Yarrow Point Entry Drive Improvements
Yarrow Point, WA

DRAWING TITLE
PLANTING PLAN

SHEET NUMBER
L1.0

CEMENT CONCRETE TRAFFIC CURB AND GUTTER

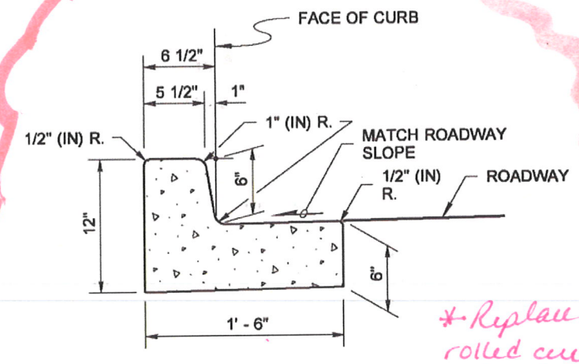
*-Replace w/ 1'-6" wide rolled curb & gutter w/ #4 rebar as provided in town detail (3 total) sheet.

ADJACENT TO BUFFER STRIP

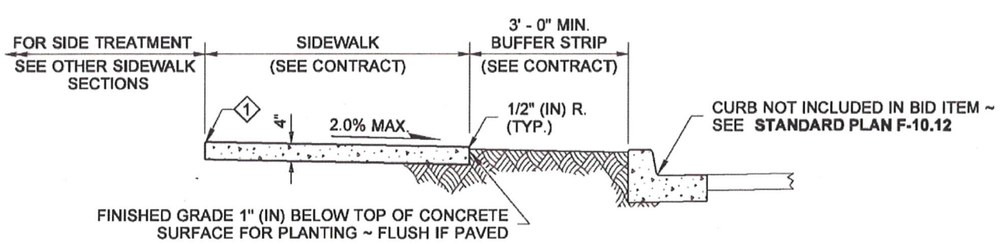
* Expansion joints every 12 ft @ 180 ft (~17 total including @ beginning & end)

PLAN VIEW

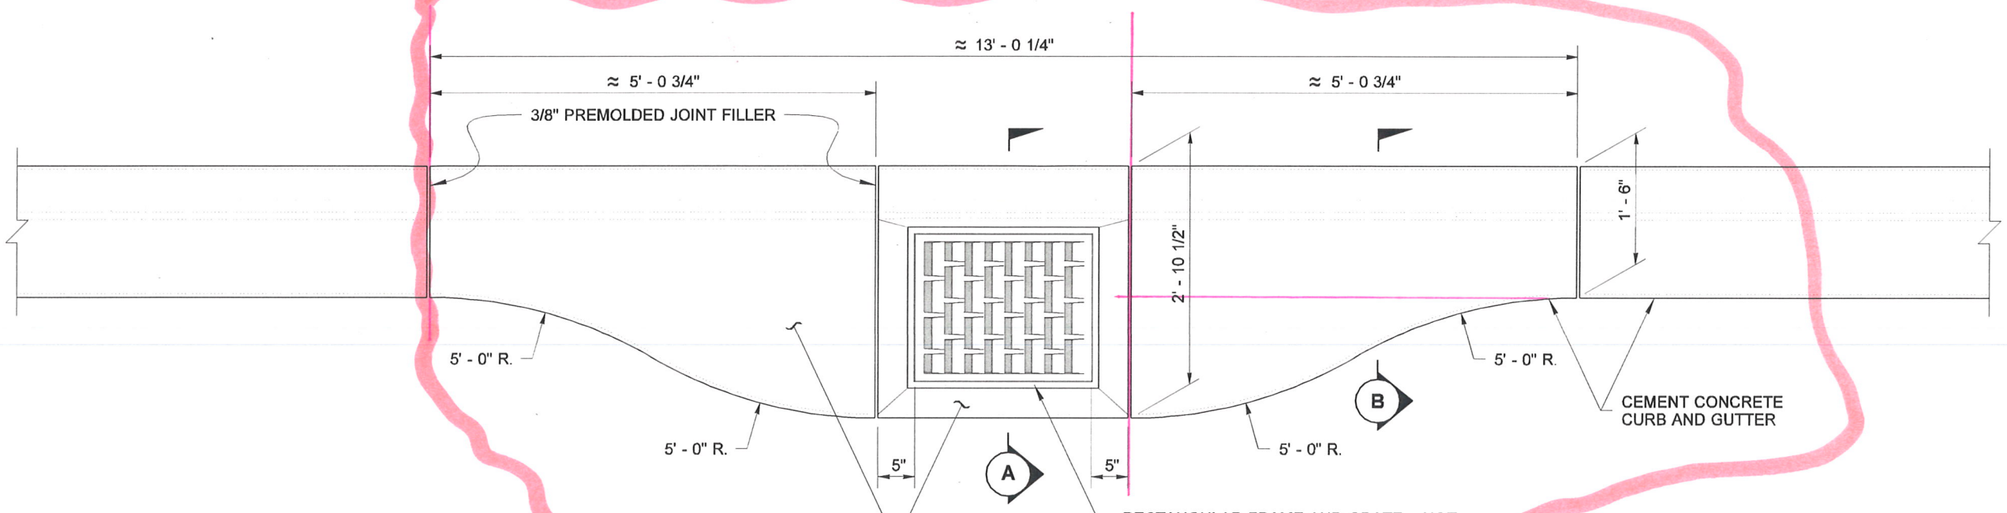
*1 CB location included @ northern end.
